## MPS 5 – Change of top-fixation

### 1. General Overview

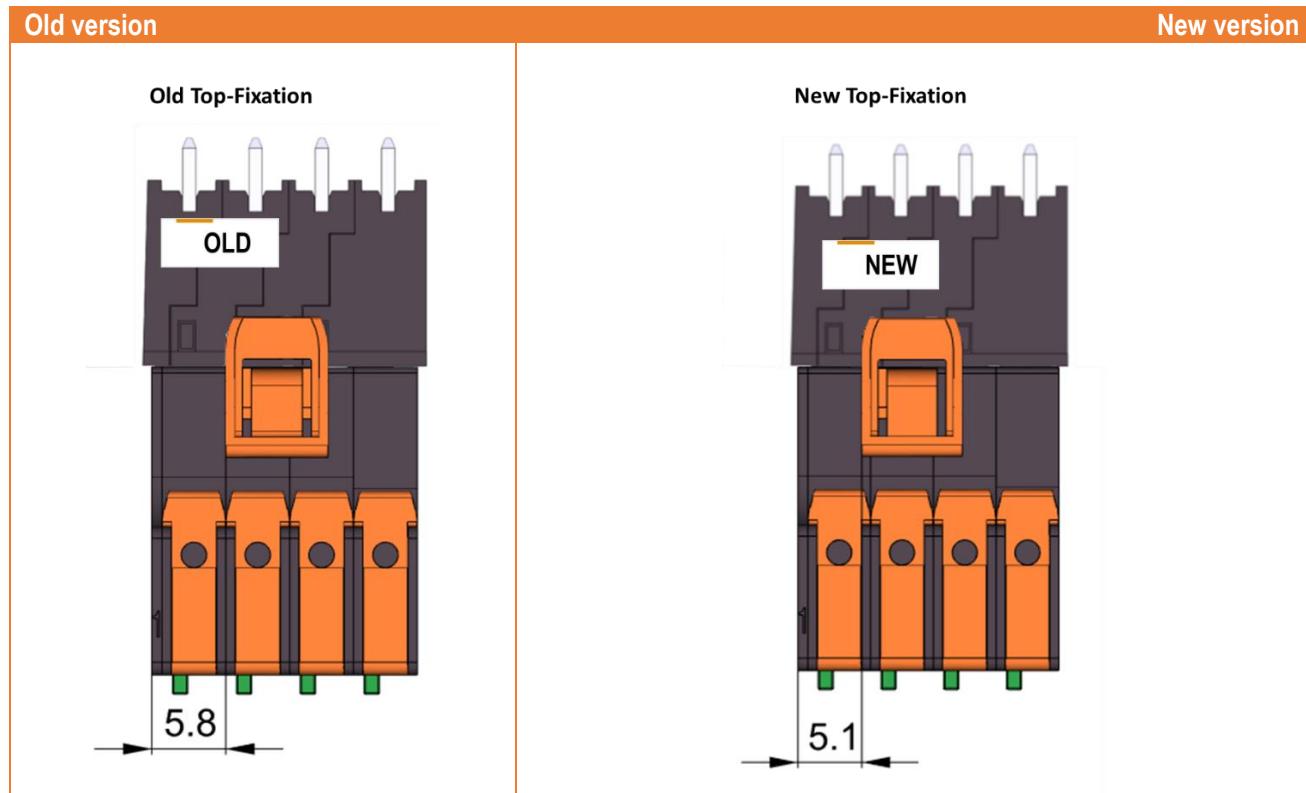
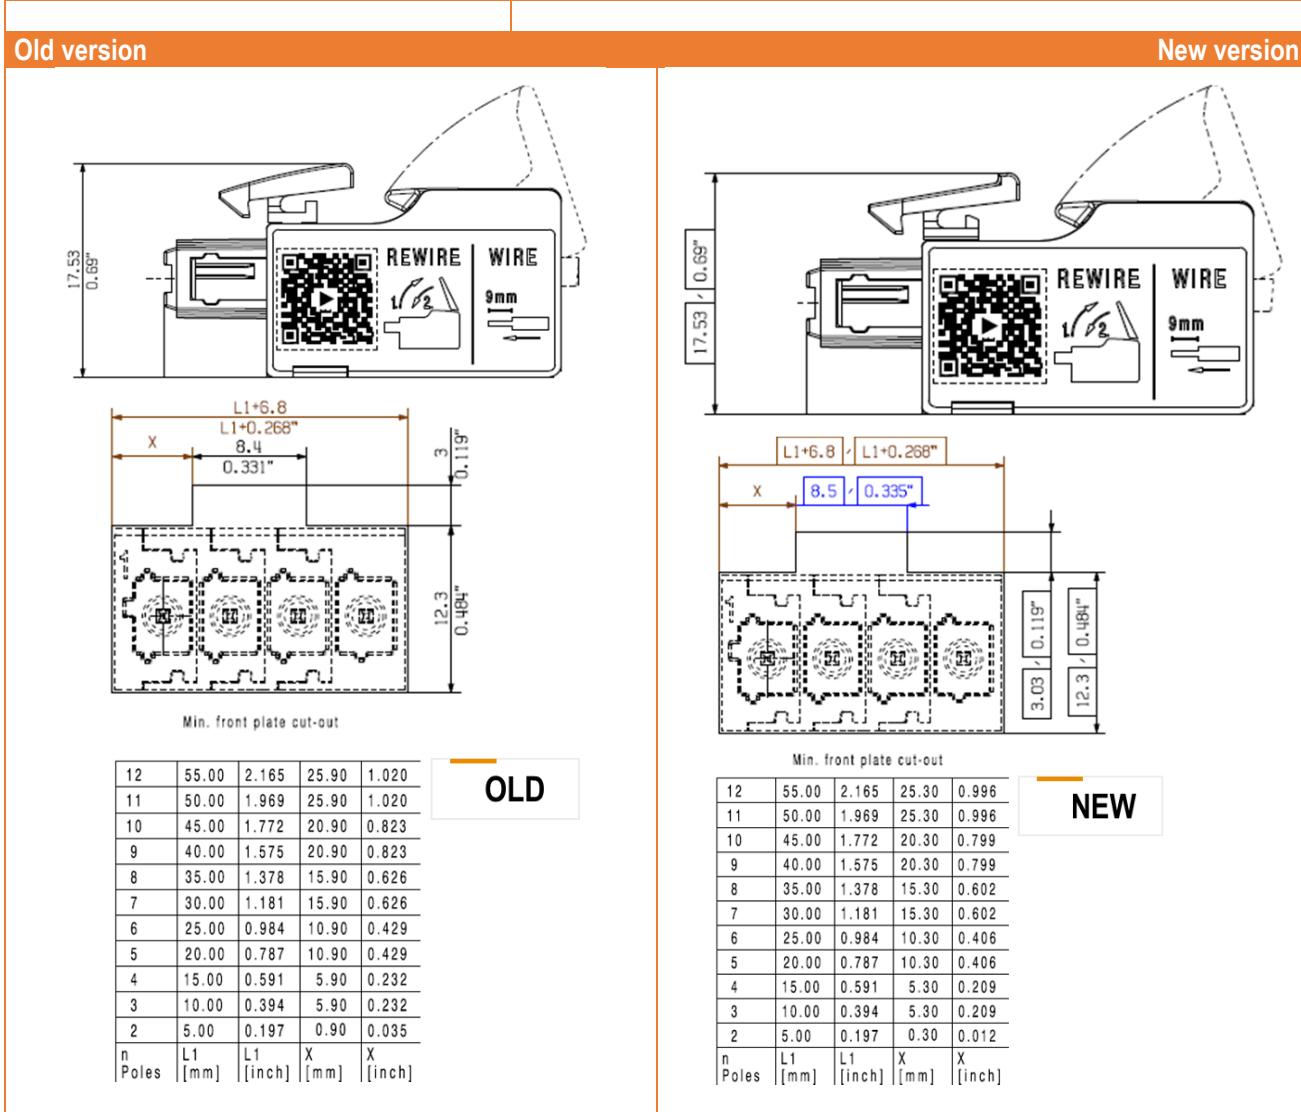
The top fixation has been slightly contour modified with an operating edge. In addition, the lower bar has been optimized for a better performed unlocking. The dimensions of the top fixation remain unchanged, but the position of the top fixation on the product changes by 0.7 mm in the direction of the first pole.
